CITY OF SAN ANTONIO

Re: Laura Heights

MDP # 870

The City Staff Development Review Committee has reviewed Laura Heights Master Development Plan **M.D.P. # 870**. Please find enclosed a signed copy for your files. Your plan was accepted however please note the following:

PUD MASTER DEVELOPMENT PLAN
LAURA HEIGHTS
BEXAR COUNTY, TEXAS

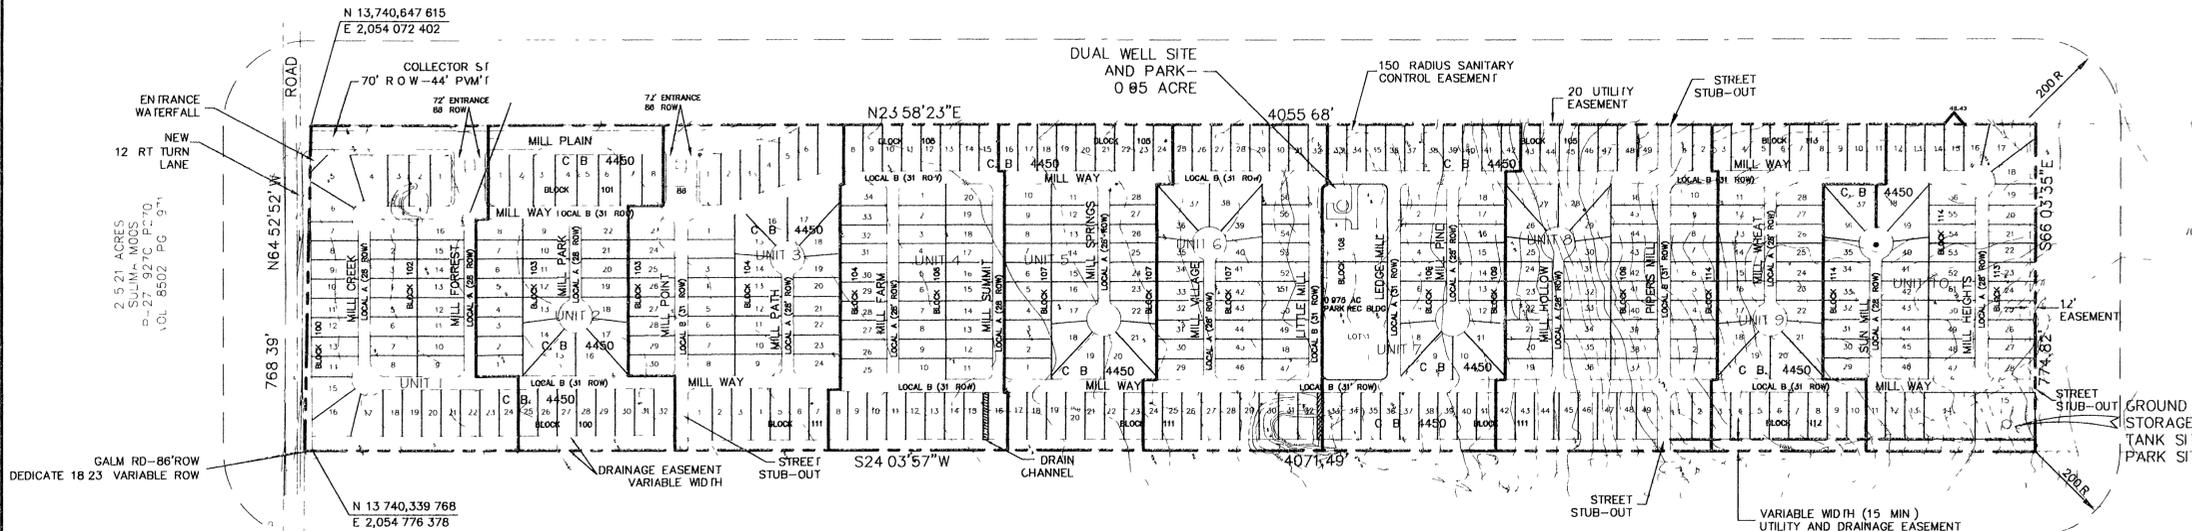
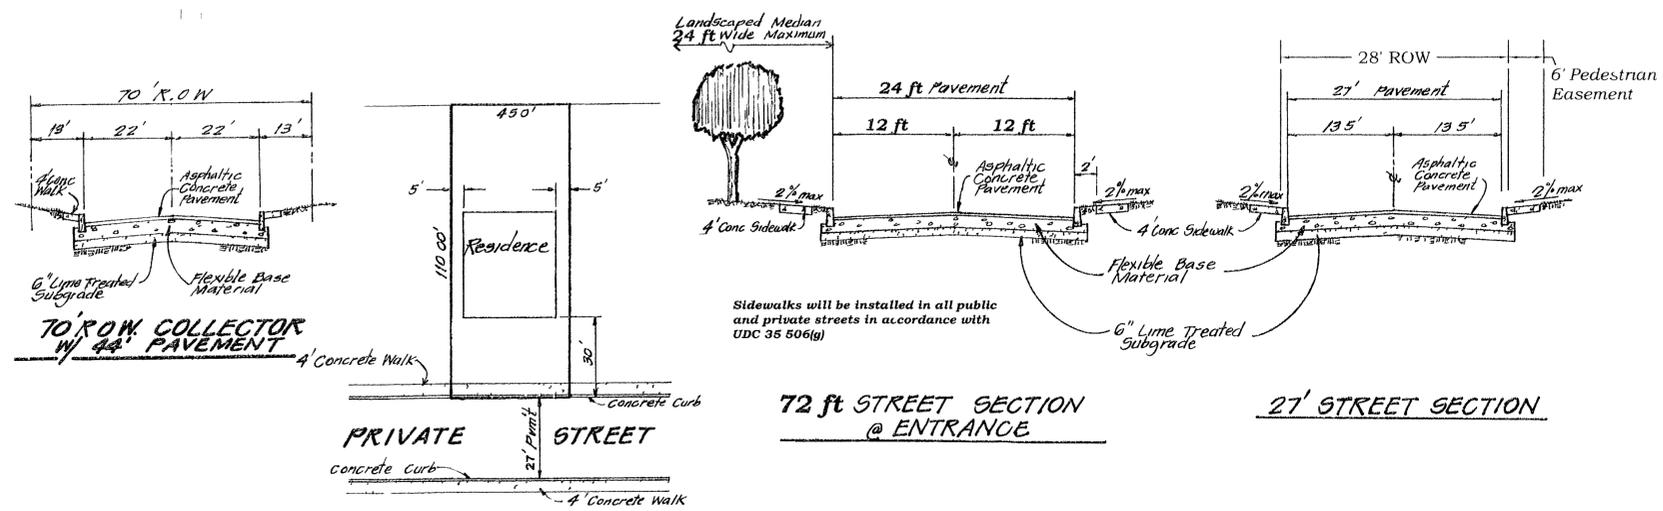
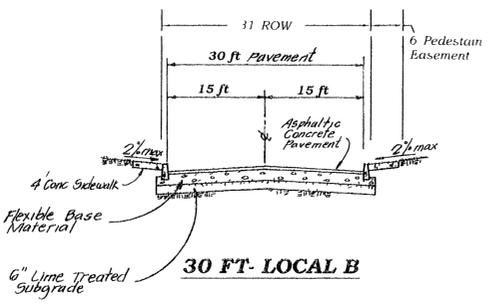
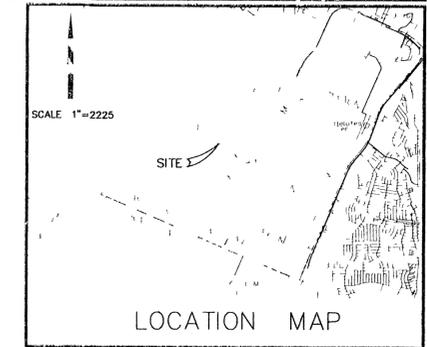
- In consideration of public safety and convenience, excessive grades by reason of topography should be avoided in street layouts and arrangements.
- Any access and R.O.W. issues along state facilities will need to be resolved with the **Texas Department of Transportation (TXDOT)**. For information about these requirements you can contact TXDOT at 615-5814.

- **Historic** indicates that
 - The Texas Site Altas indicates that no archaeological sites have been previously identified within the above referenced property. However, the project area is within the Culebra Creek drainage area, an area known to contain significant archeological deposits. Therefore, there is a **high probability** that the property may contain sites, some of which may be significant. Thus, before any work that might affect any sites is begun, we recommend that a qualified professional conduct an archaeological investigation of the property

- **DSD – Traffic Impact Analysis & Streets** indicates the following requirements and on-site improvements are necessary and shall be provided by the developer, on and before the completion date of Laura Heights:

- All access roadways shall provide clear sight distance on all existing and proposed roadways in order to provide adequate obstruction free viewing distances for approaching traffic. All signage, landscaping, and improvements shall be selected and located so as to not block these clear sight distance areas.

- The developer shall be responsible for providing right-turn deceleration lanes as well as left turn lanes, with storage lengths and bay taper as it relates to the submitted TIA traffic counts, (Uniform Development Code (UDC) – 35-502(a)(7), subsection C.

- Sidewalks along all interior and exterior roadways are to be installed in accordance with UDC 35-506(q).
- **Parks** has indicated that amenities to be provided are as follows:

- Playground
 - Swimming Pool (2,500 sq.ft.)
 - Recreation Center
 - Athletic Courts
- **Bexar County** states the following improvements will be provided by the developer prior to completion of the Laura Heights Subdivision:

- Secondary access onto the public collector must be secured prior to the approval of any plat or combination of plats exceeding 125 dwelling units.
 - All decorative structures shall be placed within private property and not within public right-of-way.

- All traffic controls shall be warranted as per the Texas Manual on Unified Control Devices and approved by Bexar County.
- It will be expected that you will plat all of the property depicted in your Master Development Plan (M.D.P.) to include floodplains, drainage areas and open space.
